ADDENDUM 2

12" Public Sewer Extension Phase 3 Project Number: 2020-007B Bid No. 2644

October 29, 2024

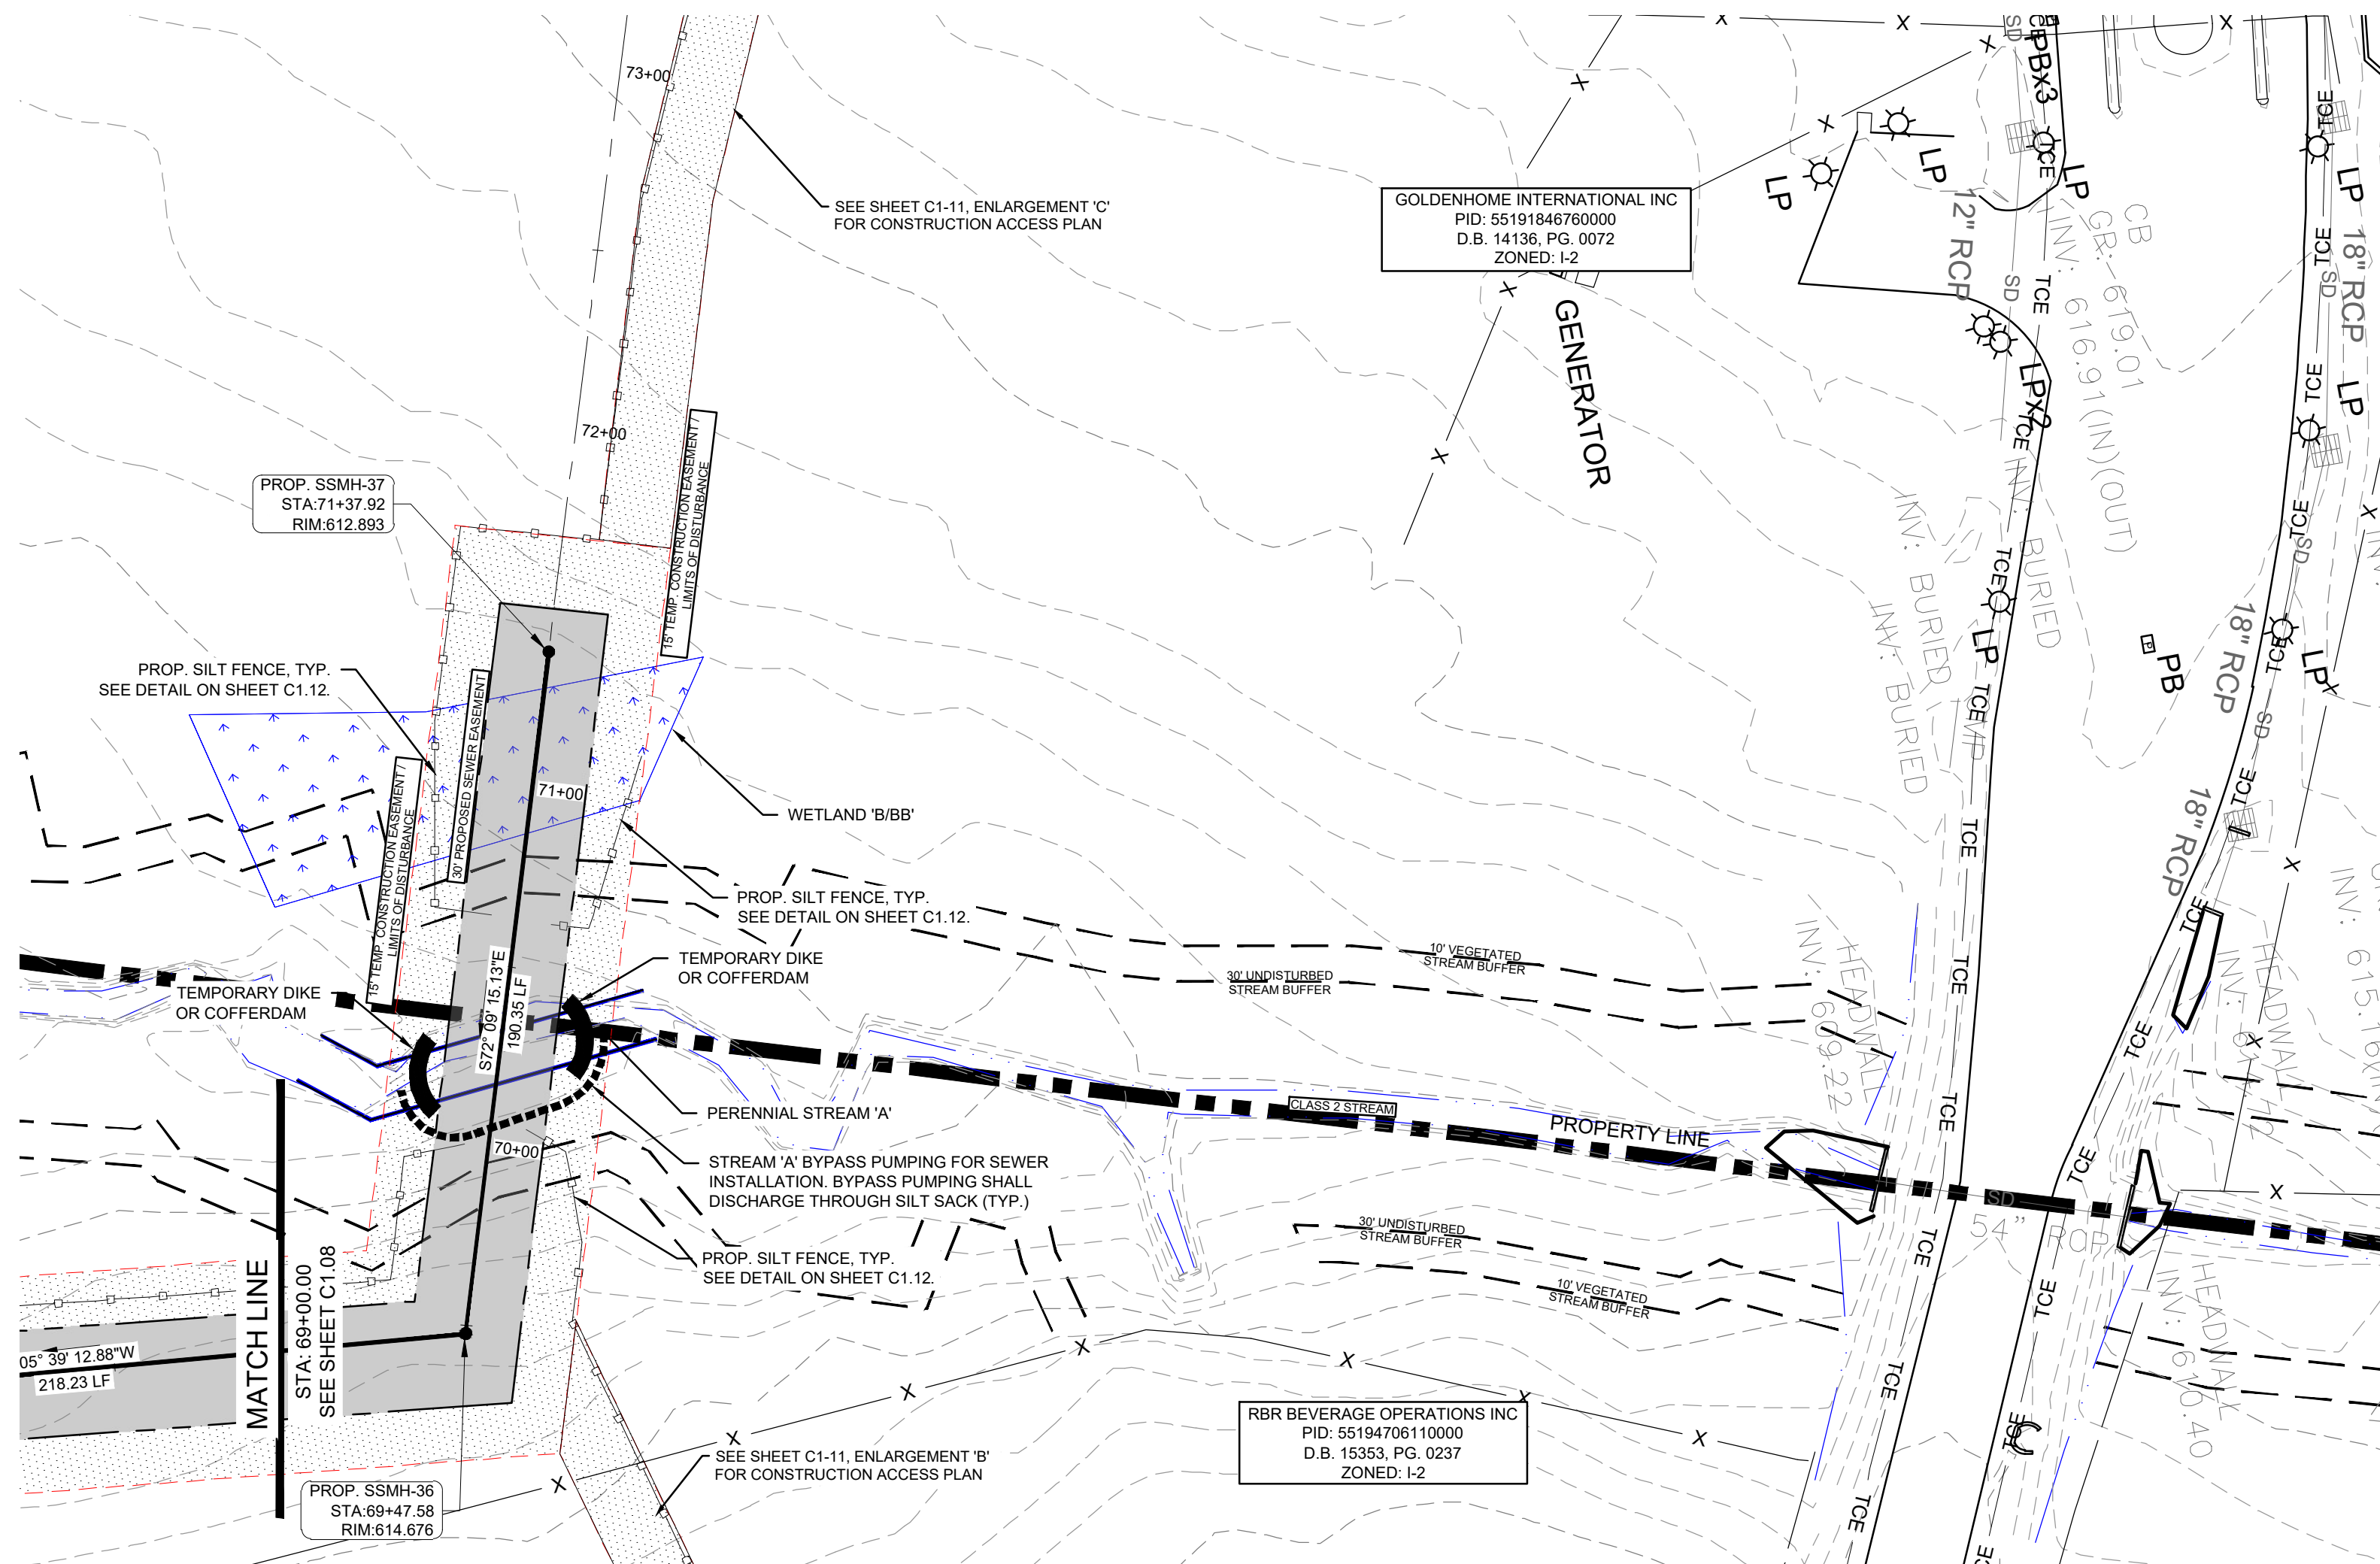
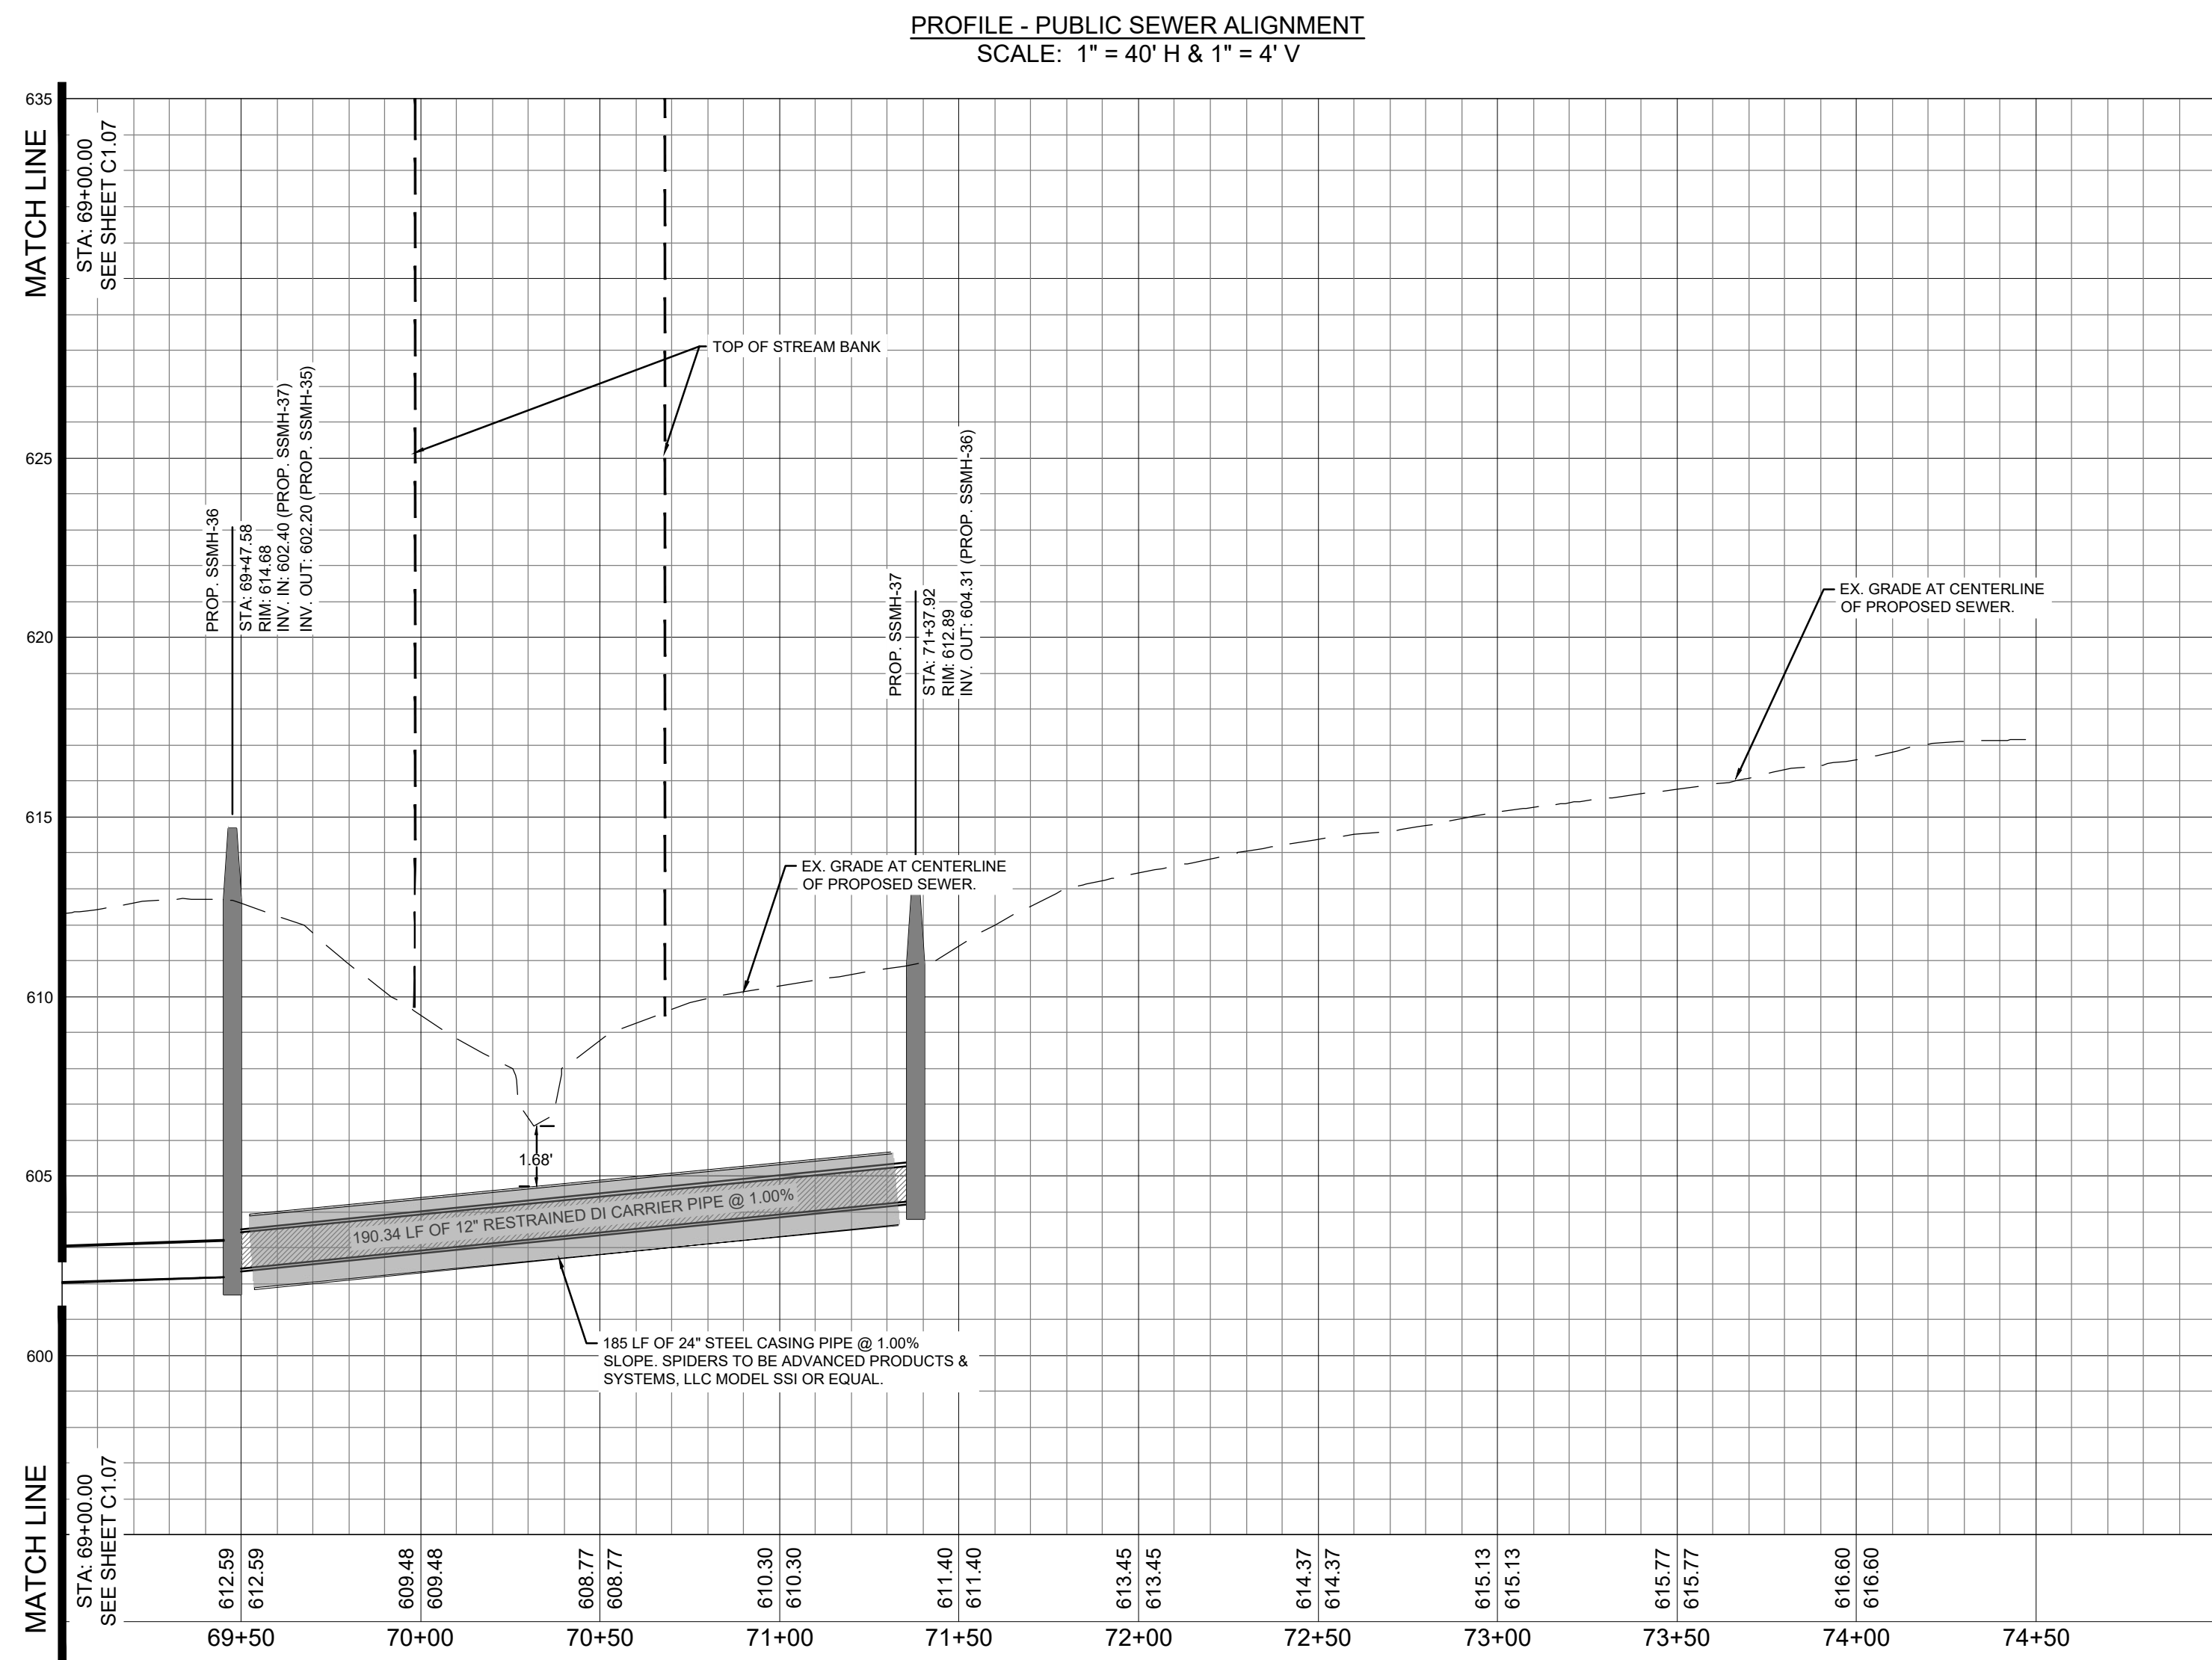
2. For the road crossing from MH16 to MH17 we will be 20' deep open cutting this road and there will likely be rock. There is not a way to keep this road open to traffic to be able to complete this work. Will we be able to close the road completely? Does the business have another way in and out that they can utilize? *There is access from Roberta Road. However, this work should be performed by jack and bore methods. Revised plan sheets are included in this Addendum.*
